Symptom - Body Exterior - Filler Flap is Jammed/Stuck: Reworking top centering bar on tank module (SY 32/18)

Model Line: **Panamera (97C) – Sport Turismo**

Model Year: **2018**

Subject: **Tank module**

Reworking top centering bar on tank module

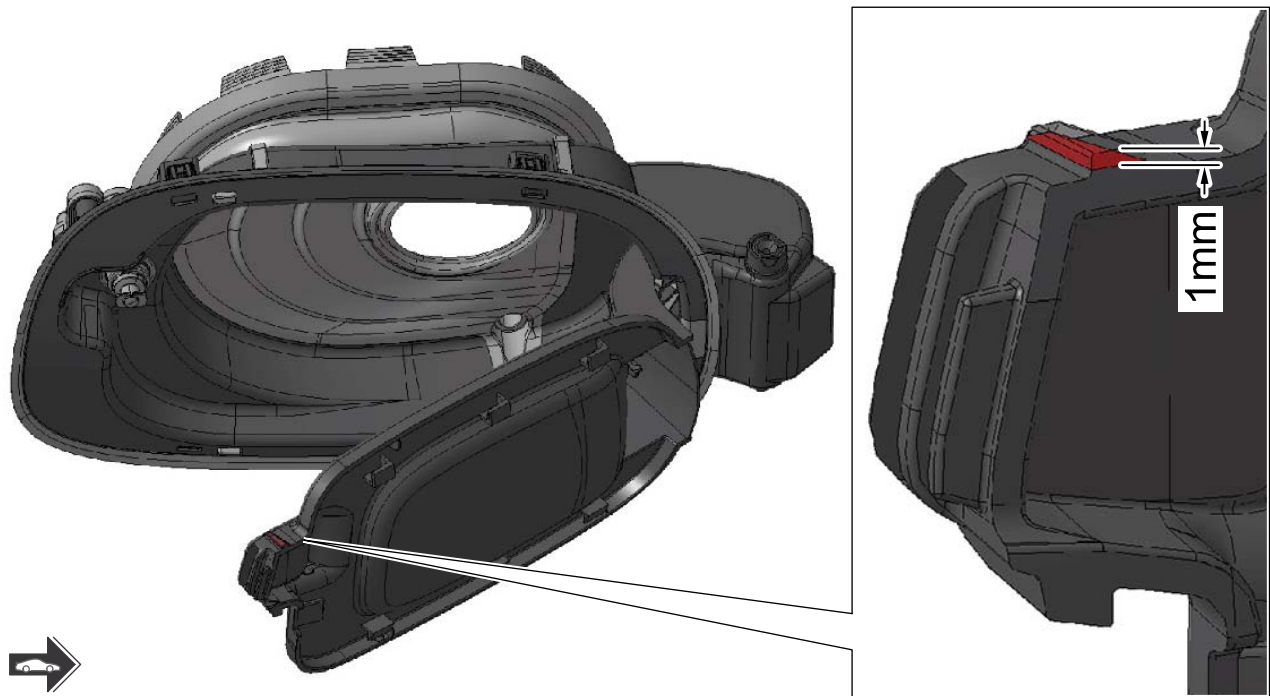
Symptom: The filler flap is difficult to open or close.

Cause: The gap dimension between the tank cap and seal may be too small, making it difficult to open or close the tank cap.

Remedial Action: Rework the **top** centering bar on the tank module.

2.1 Remove 1 mm from the **top** centering bar using a suitable tool.
